# SERVICE BULLETIN

SUBJECT: HORIZONTAL STABILISER - WEATHER PROOFING

S/B No. NMD-55-7  
Page 5 of 5

FIGURE 1  
 TAILPLANE  
 INVERTED PLAN VIEW

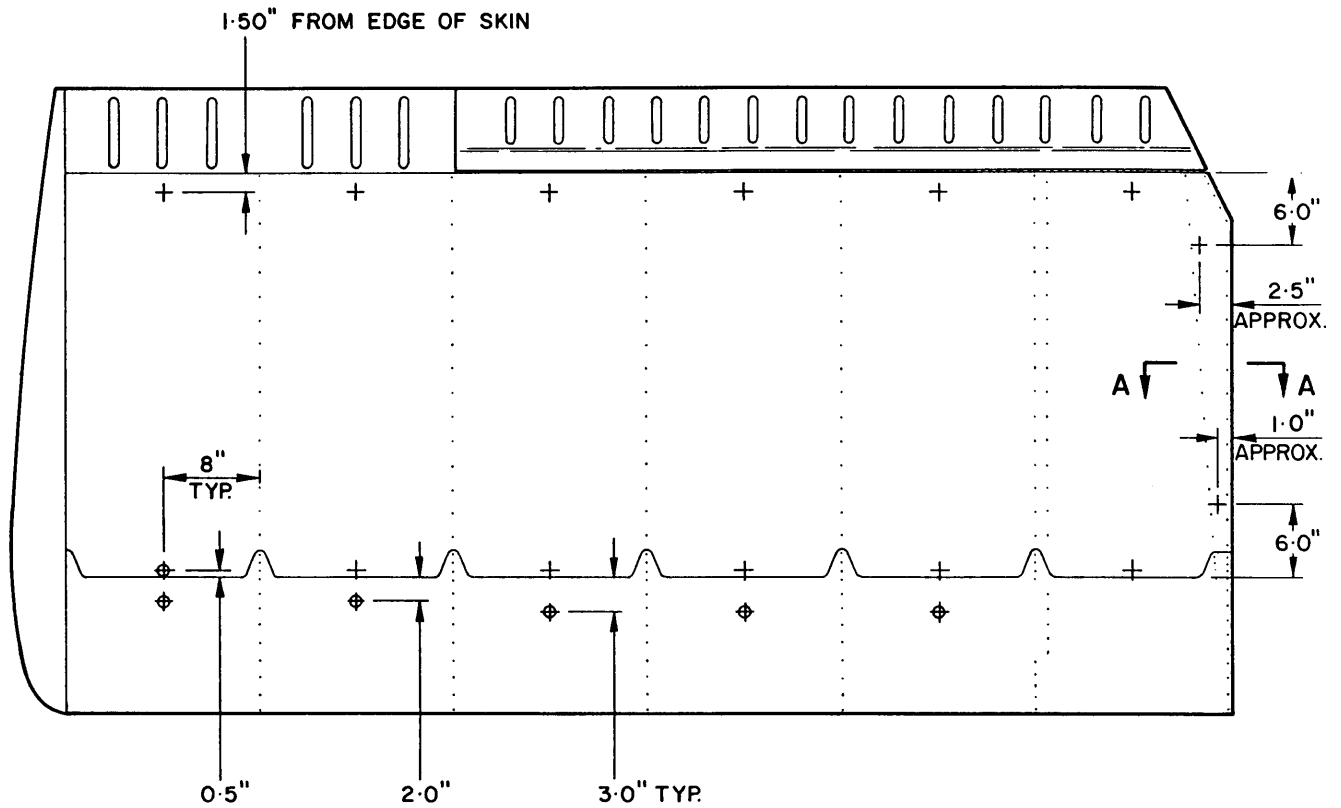
Additional drainage holes are drilled and possible water ingestion locations are sealed.

Provide new drain holes of 3/16" dia. in the underside of the horizontal stabiliser at the locations shown in figure 1.

+ NEW DRAIN HOLES - 5 mm OR  $\frac{3}{16}$ " DIA.  
 Ⓢ EXISTING HOLES

ALL DIMENSIONS FROM EDGE OF SKIN LAP.  
 ALL DRAIN HOLES TO BE .375" FROM ANY RIVET.

PROTECTIVE TREATMENT  
 FOR HOLES :-  
 ALODINE 1200  
 OR - IRIDITE 14/2  
 PRIME WITH EPOXY PRIMER  
 OR ZINC CHROMATE

FIGURE 2

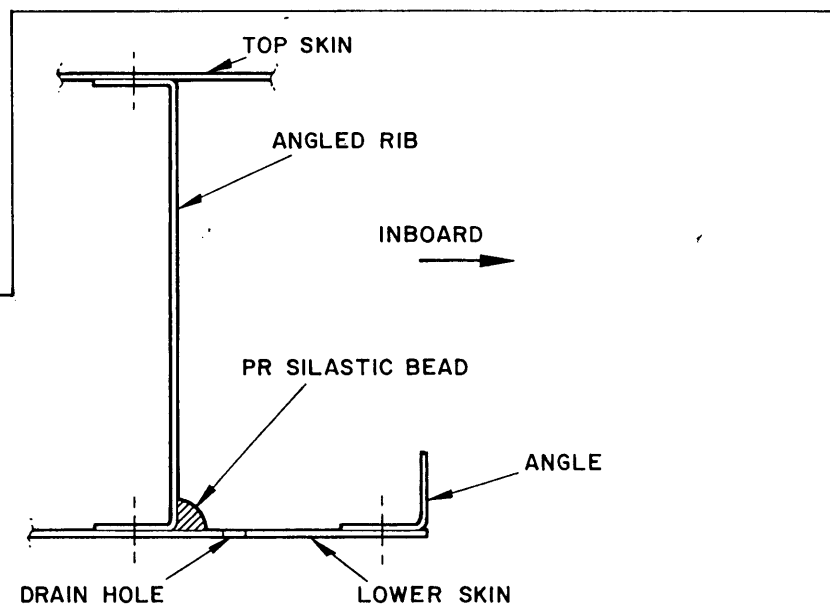
Remove the horizontal stabiliser (Ref. MM55-20-00). Form a sealing bead at the lower edge of the inboard ribs of the horizontal stabiliser as shown on figure 2. Bead may be made from PR or Silastic compounds. Test seal to ensure water does not leak into horizontal stabiliser.
